Application No: DA-950/2025/A
Date: 21/7/26

SECTION 4.55 PACKAGE

DEMOLITION OF EXISTING DWELLING AND CONSTRUCTION OF NEW DOUBLE STOREY SEMI - ATTACHED DUAL OCCUPANCY

35 DENNIS STREET LAKEMBA 2195 NSW

ROOF PLAN

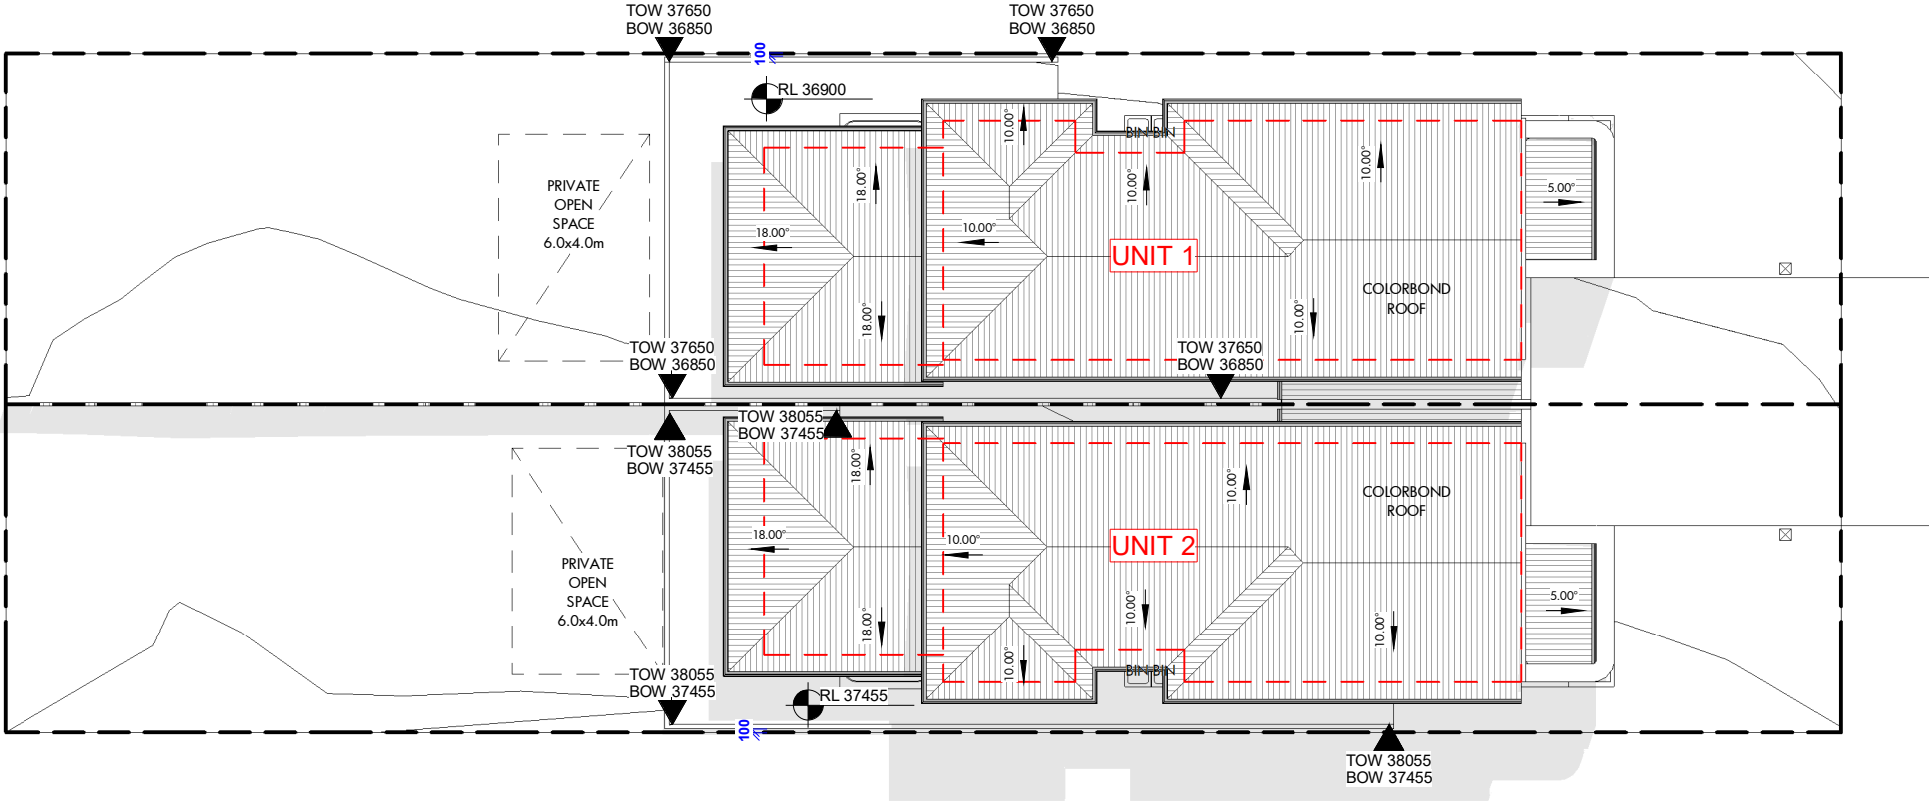
NOTE: SUBDIVISION WALL BETWEEN THE TWO HOUSES MOVED ACCEDENTLY.
NOW CORRECTED IN SECTION 4.55 APPLICATION. NO OTHER CHANGE PROPOSED.

DRAWING TITLE
GROUND FLOOR PLAN

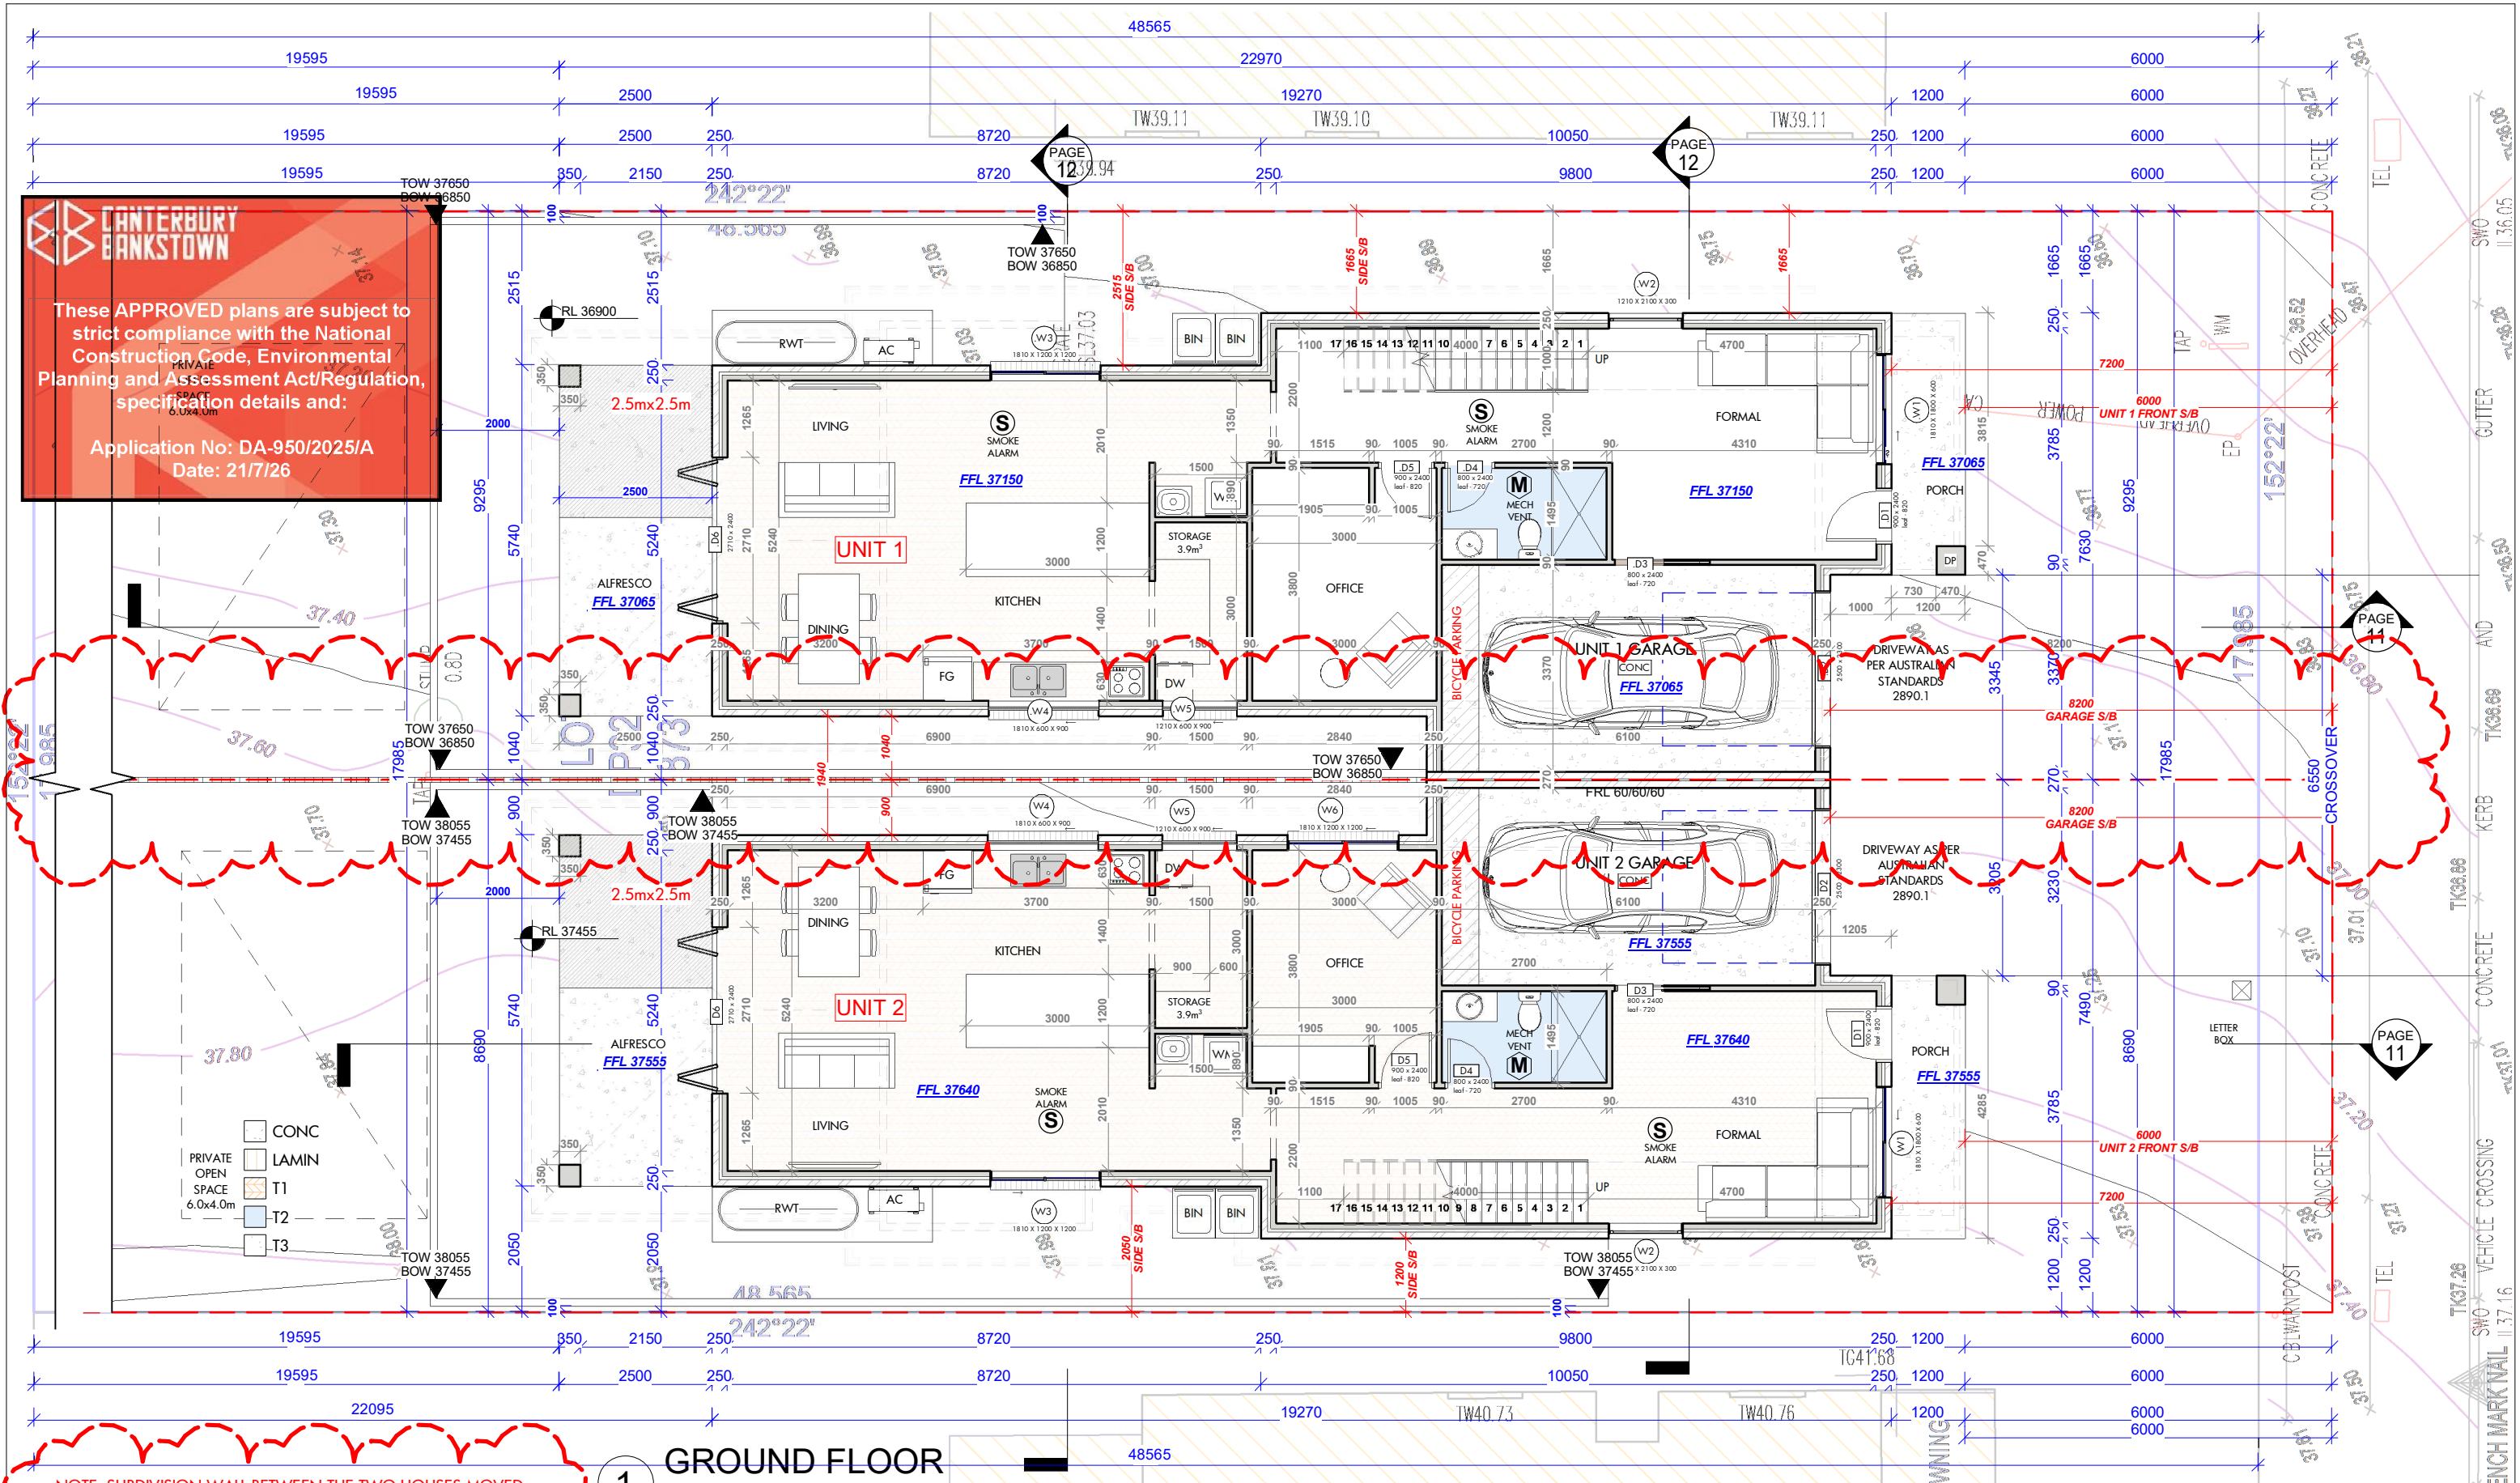
NOTE: SUBDIVISION WALL BETWEEN THE TWO HOUSES MOVED ACCIDENTLY.
NOW CORRECTED IN SECTION 4.55 APPLICATION. NO OTHER CHANGE PROPOSED.

DRAWING TITLE		
SIDE ELEVATIONS - UNIT 1		
SCALE	DATE	
1 : 100	22/12/2025 1:18:59 PM	
DRAWN	CHECKED	
RV	AI	
DRAWING NO.	PROJ. STAGE	PAGE NUMBER
2458	S4.55	S4.55 08

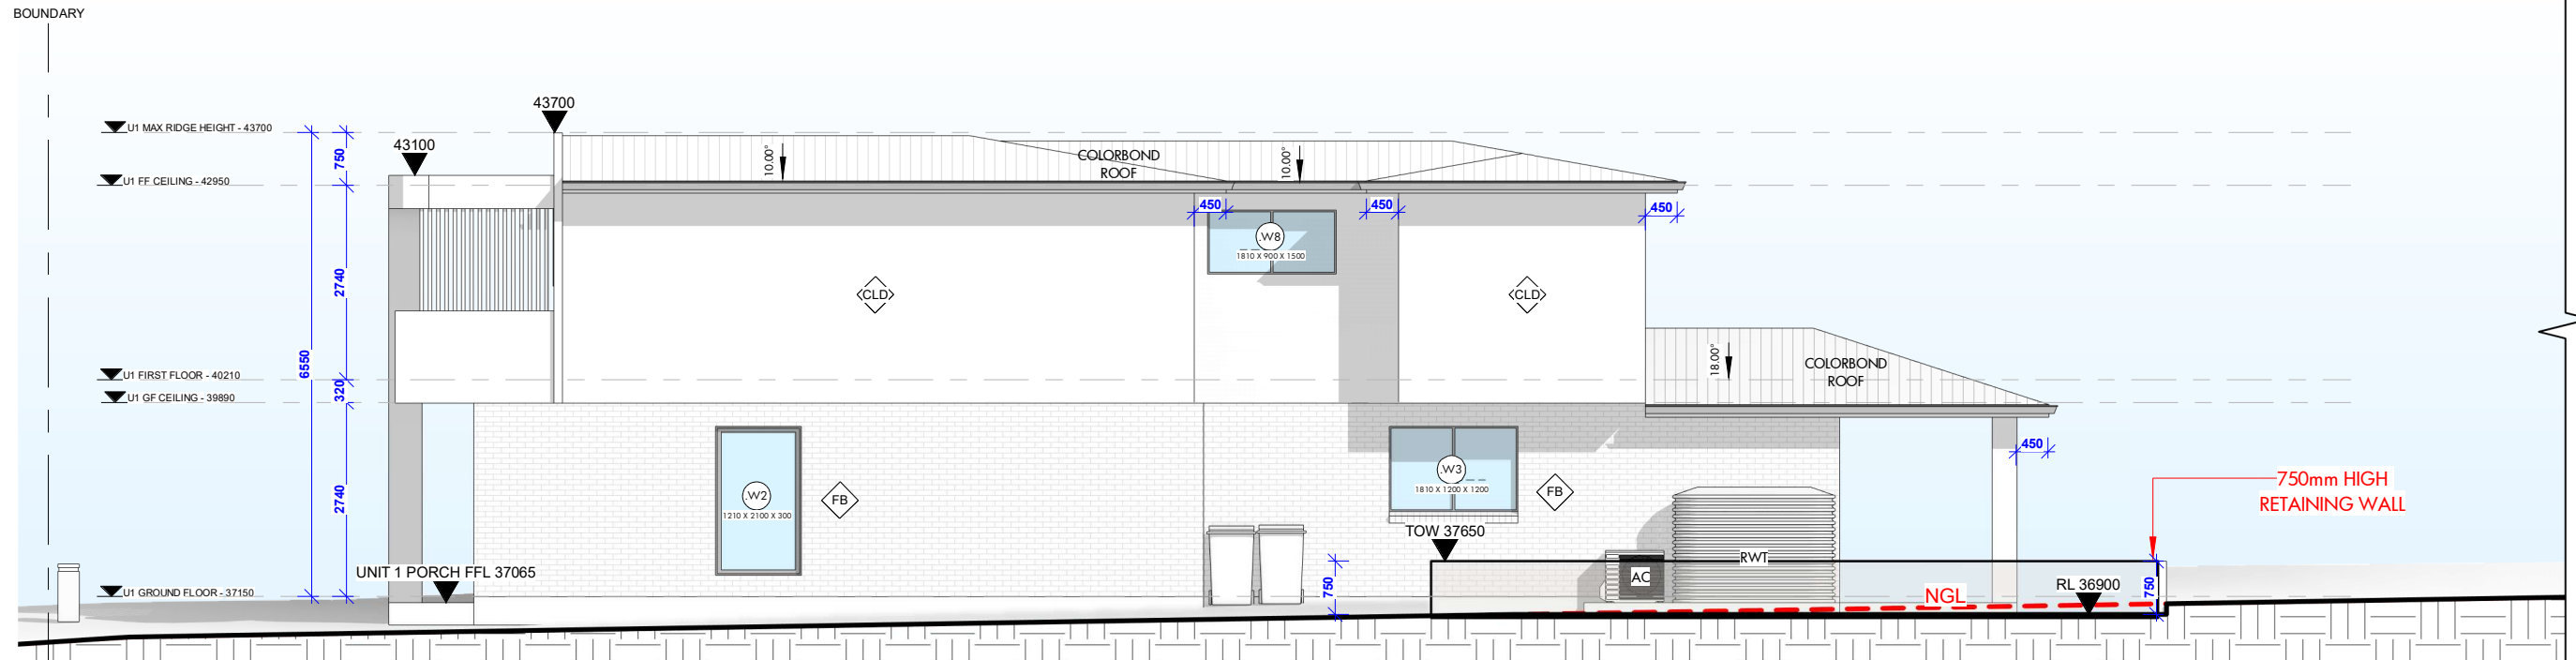
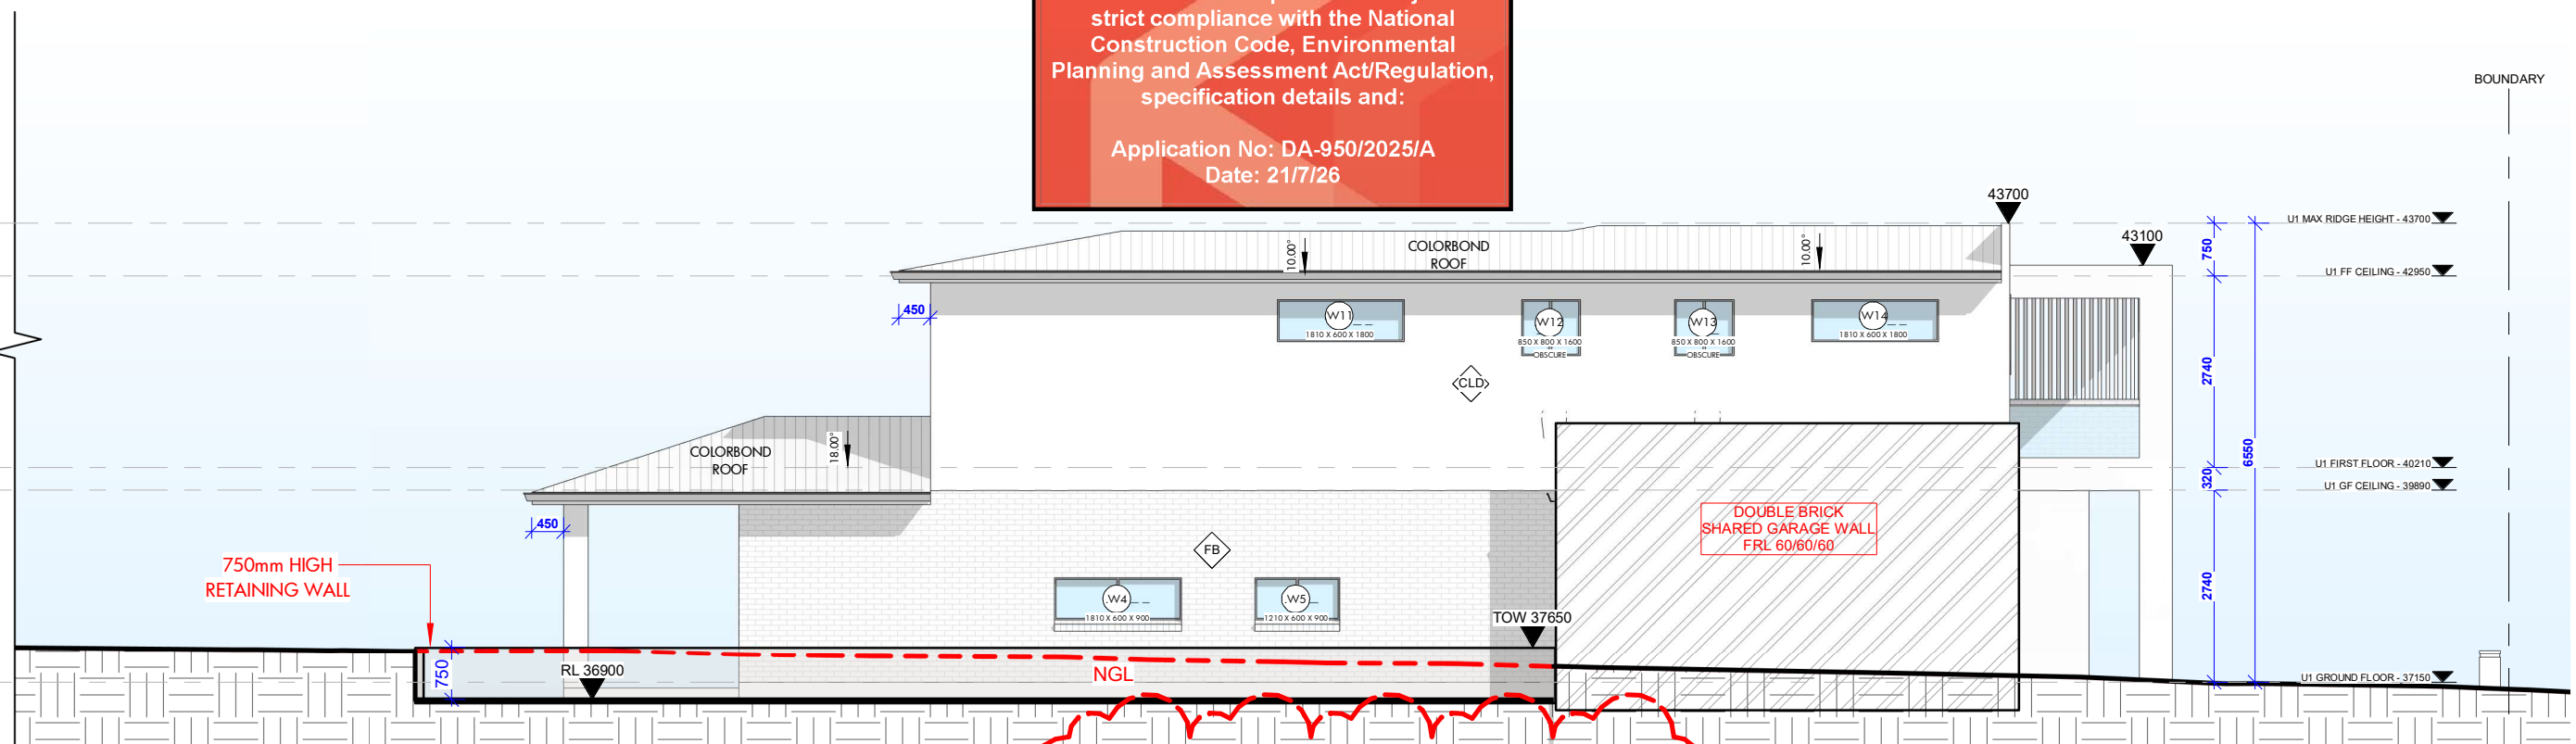
NOTE: SUBDIVISION WALL BETWEEN THE TWO HOUSES MOVED ACCIDENTALLY.
NOW CORRECTED IN SECTION 4.55 APPLICATION. NO OTHER CHANGE PROPOSED.
